## **AQUIND INTERCONNECTOR**

Statement of Common Ground Between  
AQUIND Limited and the Marine Management  
Organisation

Document Ref: 7.5.16

PINS Ref.: EN020022

Figure 1. Benthic baseline PSA results based on Folk Classification. No grabs returned from sampling stations 8 and 22. (taken from Figure 9, Benthic Ecology Survey Report)

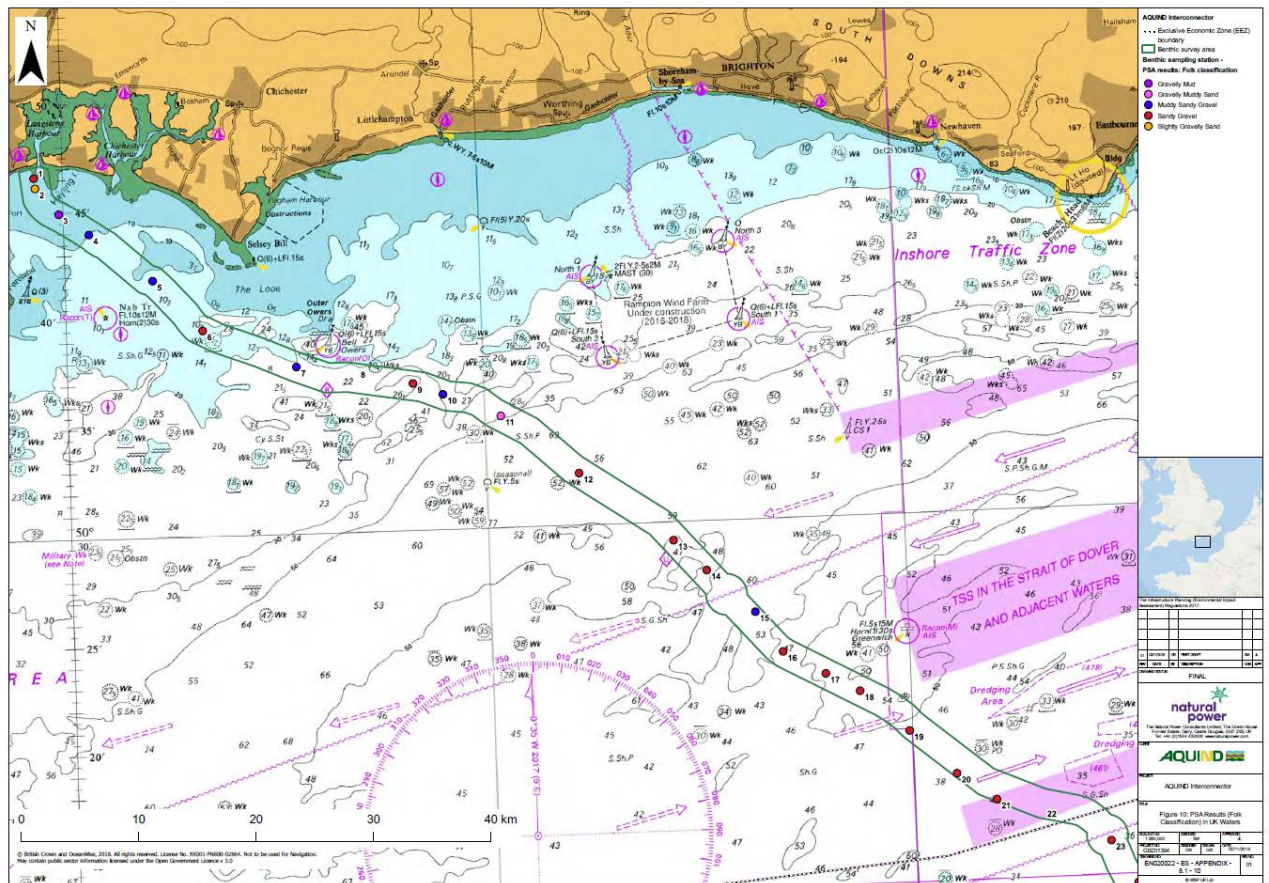
- 8.12. The applicant has noted the following in 7.4.3 (Chapter 7): “Coarse sediment has a limited affinity for sorption of chemical contaminants and therefore sediment contamination would not be expected to pose a significant risk in the offshore areas of the route given the PSD results.”

- 8.13. The point above is an acceptable premise, so long as PSD data are provided to verify that the proposed work area is appropriate. Appendix 6.3 details the grain size statistics and Appendix 8.1 details the findings of the Benthic Ecology Survey Report. Figure 1 (below) displays a map detailing the PSD of the sampling grab locations. From the location of grab station 12 up to station 23, sediment is classified as either sandy gravel or, in one instance, muddy sandy gravel. The MMO consider this acceptable evidence that sediment in the offshore segment of the cable corridor (approximately 50 km from the shore) is sufficiently coarse such that additional sample contaminant analysis is not, at this time, required.

- 8.14. In the nearshore section of the cable corridor, grab samples show a mixture of sandy gravel, gravelly mud and slightly gravelly sand, but are predominantly muddy sandy gravel. This indicates that material from the nearshore section is less consistently coarse than the offshore section. Table 1 (below) details the coordinates of the sampling locations of the sediment contaminant analysis; in order to compare how they represent the nearer shore section of the cable corridor.
